# **Strategic regional water resource solutions: accelerated gate two draft decision for Water Recycling**

The purpose of this publication is to set out our draft decision in respect of the Water Recycling strategic regional water resource solution submitted for the accelerated gate two assessment by solution owner Southern Water<sup>1</sup>. This solution consists of two options, one of 61Ml/day and one of 75 Ml/day.

**Figure 1. Water Recycling schematic**

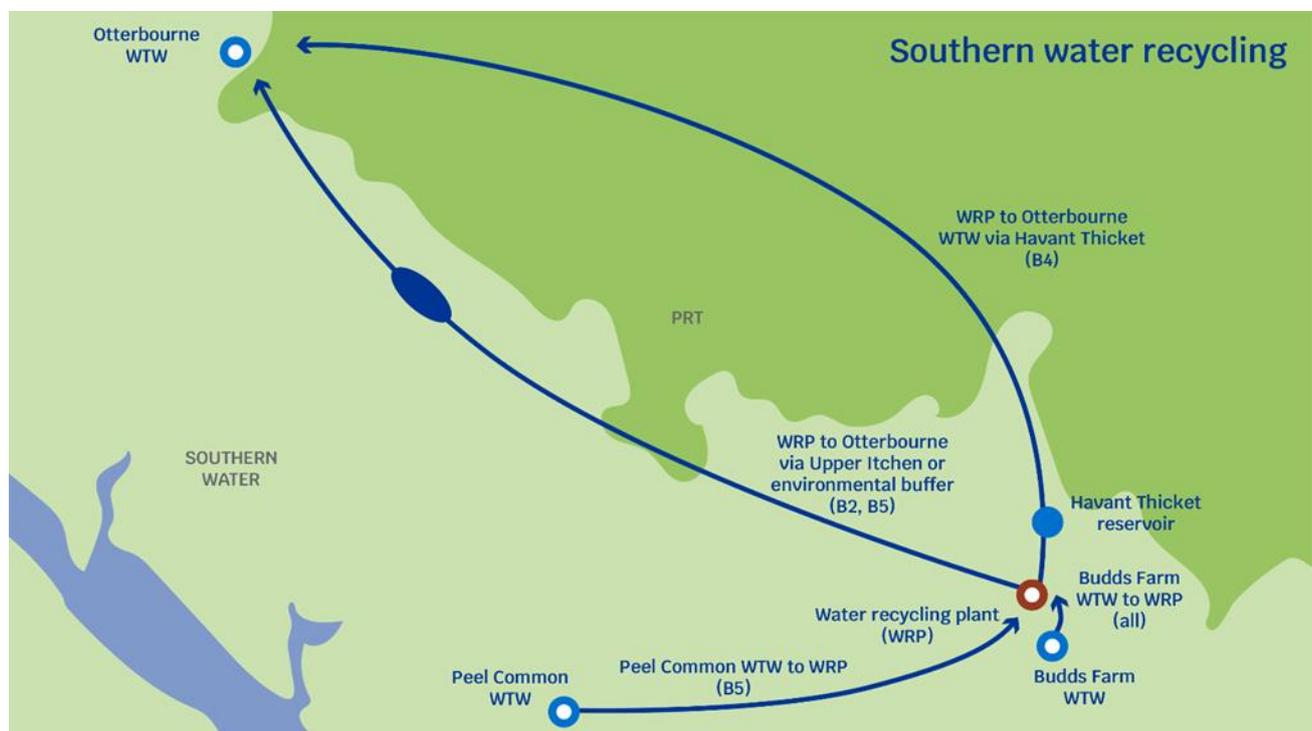
Southern Water's assessment of utilisation in a 1:500 year drought was insufficient and did not adequately consider whether the volumes of effluent from Budds Farm WwTW would be able to provide sufficient flow to the WRP for it to produce the predicted deployable output under all weather scenarios.

**Figure 2. Assessment of progress and quality of investigation**

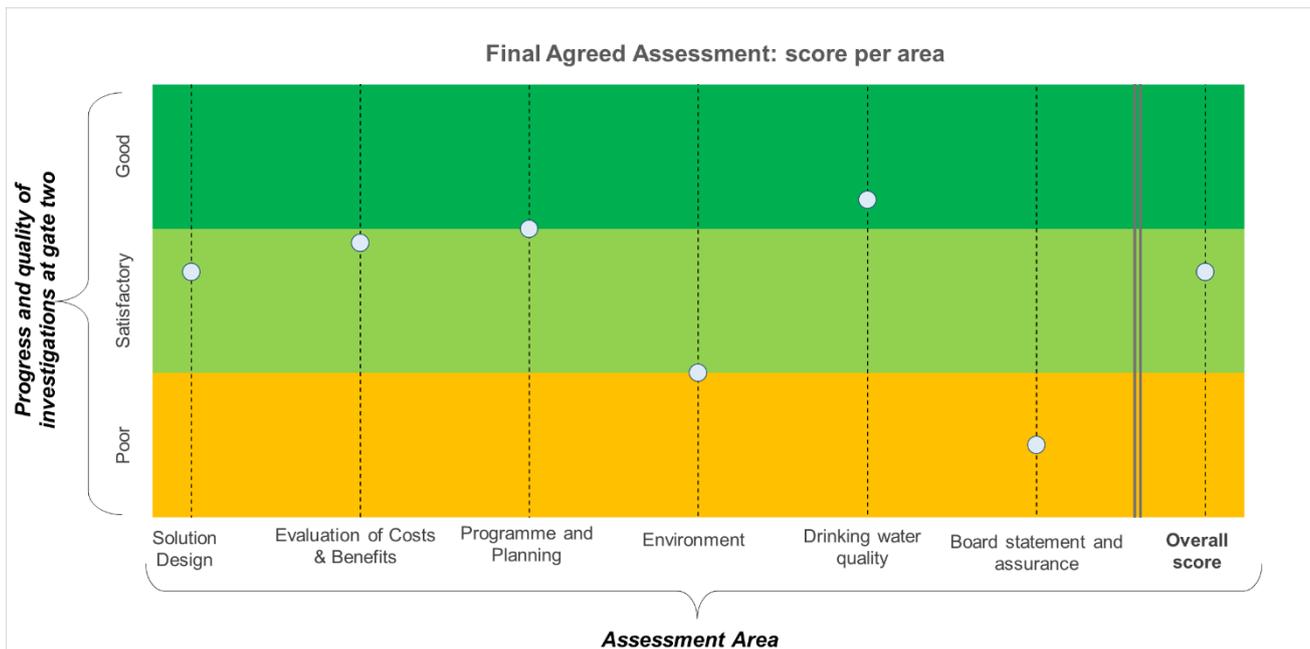
Figure 2 shows our assessment of the work completed on the solution, which was presented in the submission. Our assessment was made against the criteria of robustness, consistency, and uncertainty to grade each area of the submission as good, satisfactory, or poor in accordance with [accelerated gate two guidance](#) published on 22 February 2021 and updated in June 2021. We also assessed the Board assurance provided.

Our overall assessment of the work completed on the solution as at accelerated gate two is that it is satisfactory overall, but it falls significantly short in some important areas and is not as developed as would be expected at this stage. We explain where we have found shortfalls in the progress made and work completed on investigating and developing the solution below.
